Tender ID: 2024\_MoRTH\_833034\_1

Tender Reference Number: RO/BBSR/11017/NH(O)/2023-24

**Subject:** Widening & strengthening of Daringbadi ghat portion from km 231.000 to 256.000 (Design chainage from km 229.500 to 256.468) of NH-59 under NH(O) in Hybrid Annuity Mode Plan 2023-24 in the State of Odisha (Design length 26.968 Kms)- **Reply to pre-bid queries.**

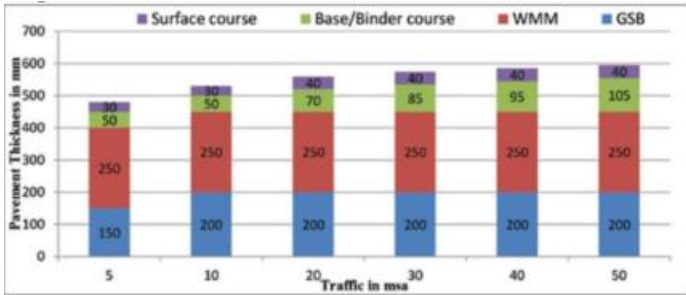
22.			As per site visit various rock fall zones and landslide zones has been identified based on hazard board shown at site some of the chainages has been marked below:-	Concessionaire has to visit the site and take care of all aspects to satisfy the design standards.

<ol style="list-style-type: none"> <li>1. 234+550</li> <li>2. 236+950</li> <li>3. 237+100</li> <li>4. 238+100</li> <li>5. 239+200</li> <li>6. 239+600</li> <li>7. 241+500.</li> </ol> <p>As a protective measure special protection is needed at all such locations but in CA there is no mention of such protection. Please bring light on the scenario, what proposal is to be considered for such locations and their treatment proposal while execution.</p>
